**From:** Griffin, Tim (Contractor)  
**Sent:** 27 August 2026 10:48  
**To:** Morris, Rachael  
**Cc:** Oliveira, Marta (Contractor); Dyer, Tim; Ellison, Mark  
**Subject:** Re: Landscaping comments DC/26/101673

Thanks for the latest revised landscape plan (R7) for this site.

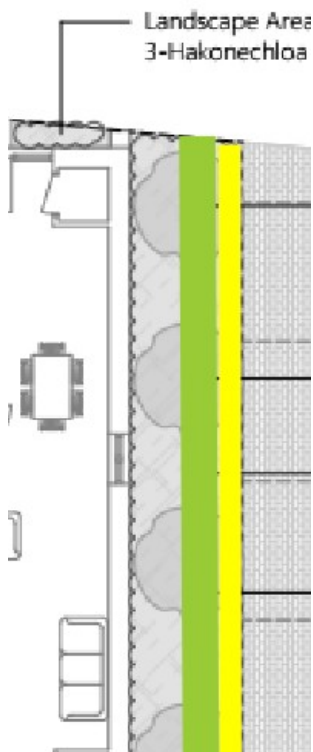
One point I made has been mis-interpreted as follows (my notes in blue):

**b/ Parking bays - set hedge planting back from end of bays by at least 0.3m to allow for vehicle overrun, otherwise the hedge will be damaged. 0.3m wide strip to be either 20mm buff shingle or bark mulch.**  
- I have removed the hedgerow entirely to allow for a wider planting bed *(Note - allow for an overrun strip as the cars will otherwise damage the planting - change as per mark up below. Yellow line - 0.3m wide 20mm buff shingle overrun strip Green line - evergreen hedge Laurus nobilis 0.8m high, 5L pot grown planted at 5 per lin m. Groundcover planting kept to rear of hedge:*

Once this minor change is made we should be able to approve the drawing.
